ADDENDUM NO. 1

TO CONTRACT DOCUMENTS FOR: Main Street Accessibility
Improvements – Phase 1 TAP9900(389)
South Main Street
Monroe City, Missouri

PREPARED FOR: City of Monroe City

ITEM NO. 1 FINAL PLAN DRAWINGS

C1.03

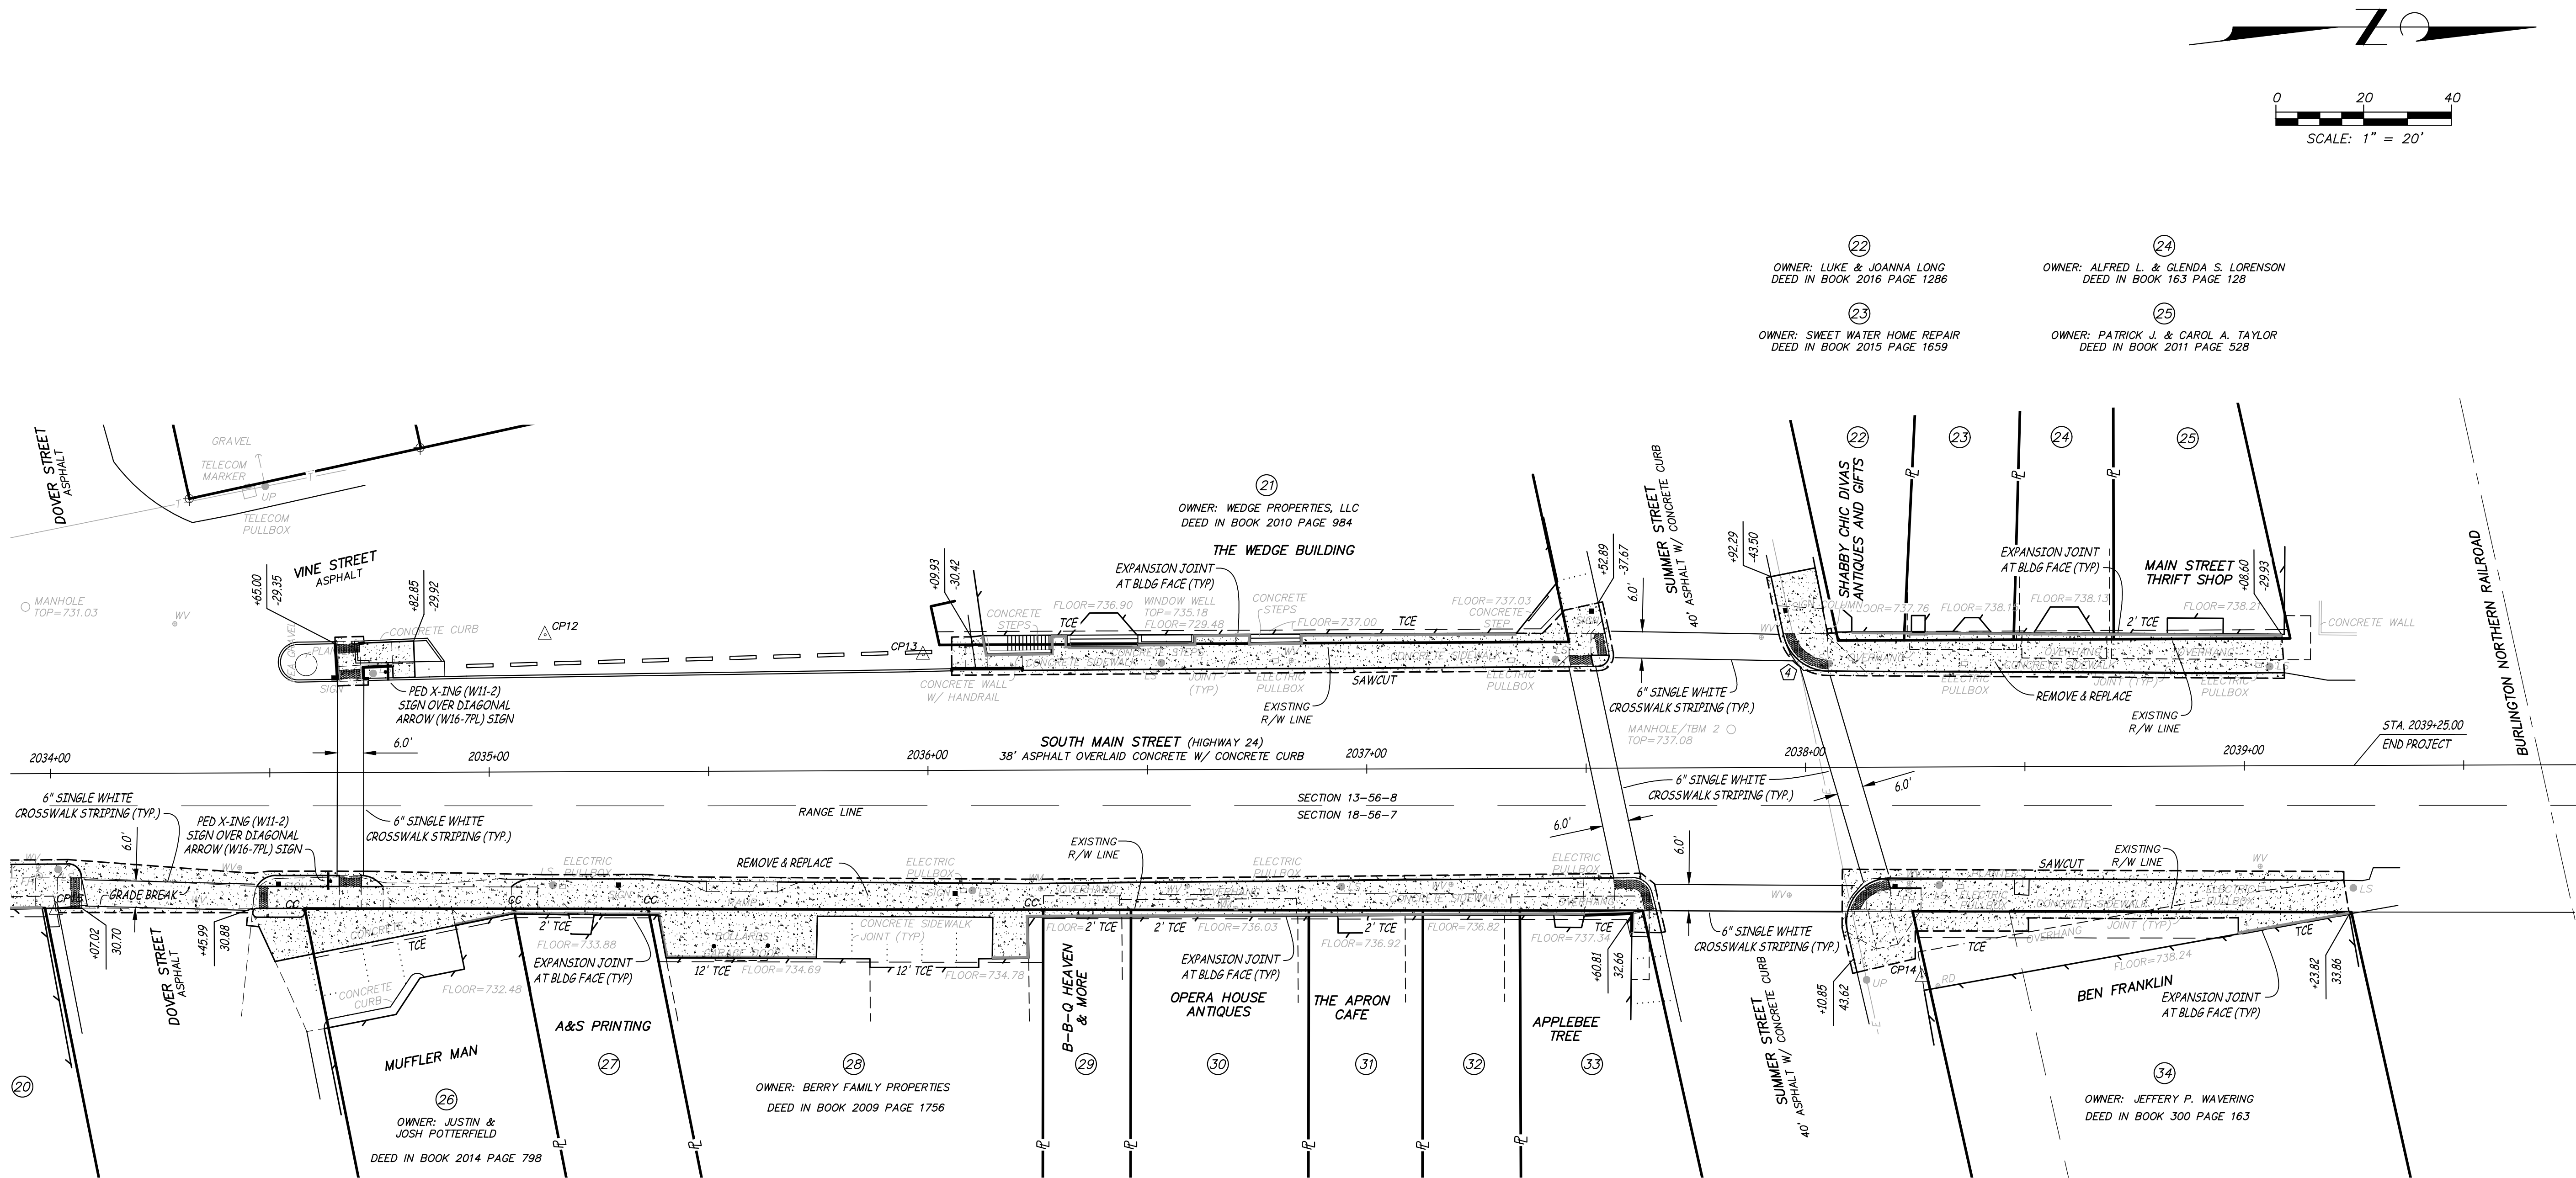
- A. The following plan sheets dated August 6, 2019 as indicated below and included with this Addendum shall replace in their entirety all earlier dated sheets of matching sheet number. Revisions indicated shall be considered general only, and the bidder shall still be required to review each sheet and verify all changes.
- B. C1.03 Site Plan: The ramp at the northwest corner of the South Main Street and Summer Street intersection has been revised.
- C. C2.01 Detail Grading Plan: The ramp at the northwest corner of the South Main Street and Summer Street intersection has been revised.
- D. C3.03 Erosion Control Plan: The ramp at the northwest corner of the South Main Street and Summer Street intersection has been revised.
